Updated Crosshead Bearing Design

For K98 and K/L90 engines

SL2016-613/NIHE

March 2016

Figure 1: Bearing of modified design at 11620 hrs.

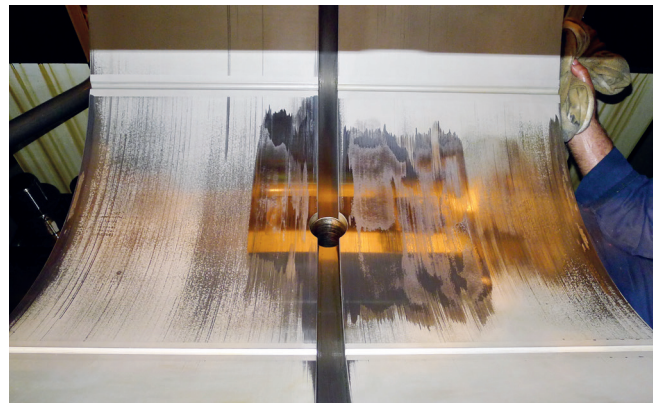
The updated design has been tested for 12000 hours in units with previous fatigue cracks of the bearing lining material. Pictures from two units are shown in Figs. 1 and 2,

where it is seen that some redistribution of the lead overlay has occurred during the test period. This is a normal and acceptable sign of adaption between the surfaces. Otherwise, the bearings have nice appearances without any signs of fatigue cracks. As a consequence of the successful service tests, the updated design is the new standard for K98 and K/L90 engines. The bearing upper shell design has not been modified.
